Access Compliance Report

Public Rights-of-Way

Intersection ID: 14423	Main Street: ALBEMARLE_RD	Cross Street: HOLLIROSE_DR	Location: NW
ADA ID: 6157BB141098	Ramp Type: Perp	Initial Pass/Fail: Fail	Overall Compliance: No
Codes/Mitigation Info/Possible Solution		Field Measurements/Component Compliance	
Severity Score: 12.5

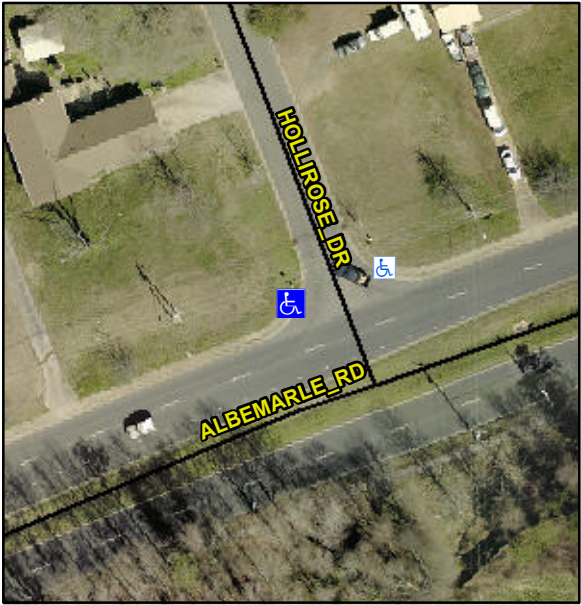
Possible Solutions:	Compliance	Description	Data	Compliance	Description	Data
	Remove & Replace Entire Ramp.	N/A	Ramp Length (in)	61.0	No	Ramp Slope (%)	8.4
<p>Surveyor Notes:</p> <p>N/A</p> <p>PROW/ADA:</p> <p>Not Found, R304.2.2</p>		Yes	Ramp Width (in)	48.0	Yes	Ramp XSlope (%)	0.4
		N/A	Flare Type LT	N/A	N/A	Flare Type RT	N/A
		N/A	Flare Slope LT (%)	N/A	N/A	Flare Slope RT (%)	N/A
		N/A	Flare Traversable LT?	N/A	N/A	Flare Traversable RT?	N/A
		N/A	Landing Length (in)	N/A	N/A	DWS Provided?	N/A
		N/A	Landing Width (in)	N/A	N/A	DWS Contrast?	N/A
		N/A	Landing Slope (%)	N/A	N/A	DWS Length (in)	N/A
		N/A	Landing X Slope (%)	N/A	N/A	DWS Full Width?	N/A
		N/A	Landing Curb? (Y/N)	N/A	N/A	DWS Offset (in)	N/A
		N/A	Shared Landing?	N/A			
		N/A	Gutter Ponding?	N/A	N/A	Gutter Slope (%)	N/A
		N/A	Gutter Lip Ht (in)	0.5	N/A	Gutter X Slope (%)	N/A
		N/A	Painted X Walk1?	No	N/A	Painted X Walk2?	N/A
			X Walk 1 Direction	To E		X Walk 2 Direction	N/A

N/A	X Walk 1 Width (in)	N/A	N/A	X Walk 2 Width (in)	N/A
			X Walk 1 Slope (%)	2.3		X Walk 2 Slope (%)	N/A
			X Walk 1 X Slope (%)	1.1		X Walk 2 X Slope (%)	N/A
		N/A	Ramp inside XWalk1?	N/A	N/A	Ramp inside XWalk2?	N/A
			Road Slope (%)	N/A	N/A	Clear Space?	N/A
			Road X Slope (%)	N/A	N/A	Clear Space to XWalk (in)	N/A
		N/A	Any Obstructions?	N/A	N/A	Storm Grate/Utility Hazard?	N/A
			Obstruction Type			Storm Grate/Utility Type	
					N/A		N/A
					Yes	Surface Condition? (G/P)	Good
Total Cost:		\$	1850.00
